**STAFF REVIEW AND RECOMMENDATIONS  
PUBLIC HEARING  
OCTOBER 6, 2021**

PRELIMINARY PLAT:      **TREASURE IS RSB B/2 L/33&34**

**CASE: 2021-144**

ABBREVIATED PLAT: FAIRVIEW EAST ADDITION NO. 1 RSB B/3 L/7  
LEGAL DESCRIPTION: SEC 19, T17N, R01E, SEWARD MERIDIAN AK  
PETITIONER/OWNER: DAN HULTQUIST  
SURVEYOR: BULL MOOSE SURVEYING  
ACRES: 4.8 ± PARCELS: 2  
REVIEWED BY: KIMBERLY MCCLURE CASE #: 2021-143

A PLAT OF  
**FAIRVIEW EAST  
ADDITION No. 1  
LOTS 7A & 7B, BLOCK 3**

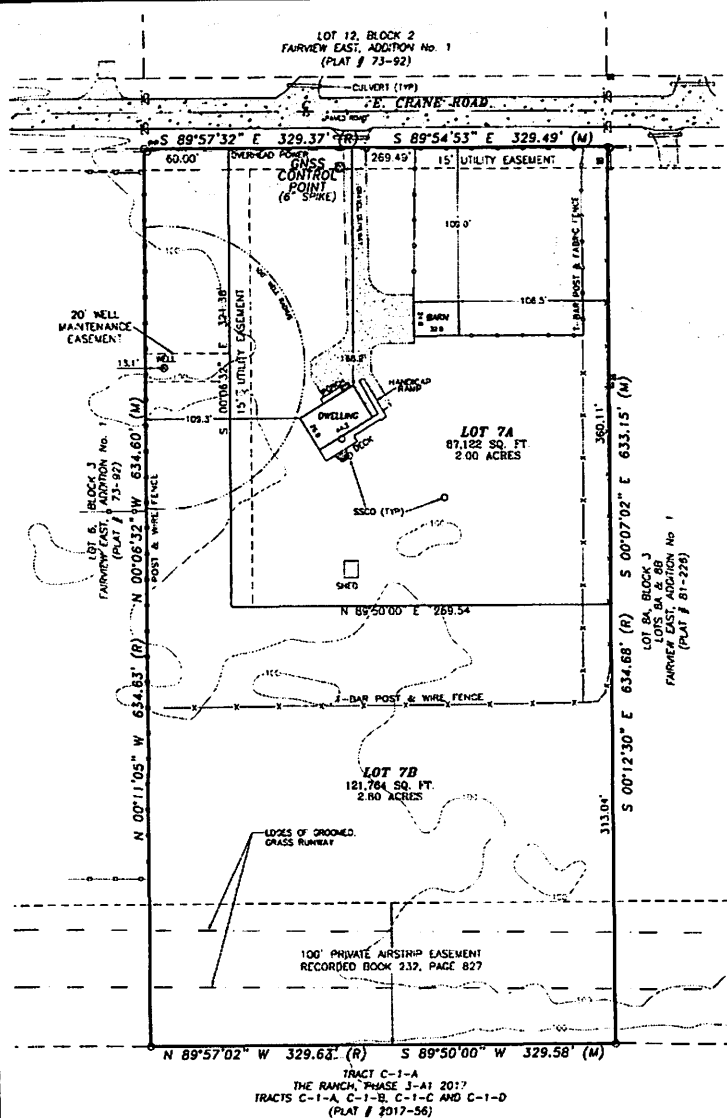
The legal description in the title block needs to show the Section to be 19.

Please see attached easement recorded on September 17, 2021 Document number 2021-027575-0. Will need to be added to the plat notes for MEA Electrical Line Easement on property. MEA has no other comments.

**Utilities:** (**Exhibit F**) MTA and Enstar have no comments or objections. GCI commented the legal description in the title block needs to show the Section to be 19. MEA requests a newly recorded MEA Electrical Line Easement to be added to the plat notes (see **Recommendation #5**).

4. Show all easements of record on final plat.
5. Show newly recorded MEA easement in the plat notes on final plat.
6. Apply for driveway permits from MSB for all driveways accessing E. Crane Road and provide copy to Platting staff.
7. Submit recording fees, payable to Department of Natural Resources (DNR).
8. Submit final plat in full compliance with Title 43.
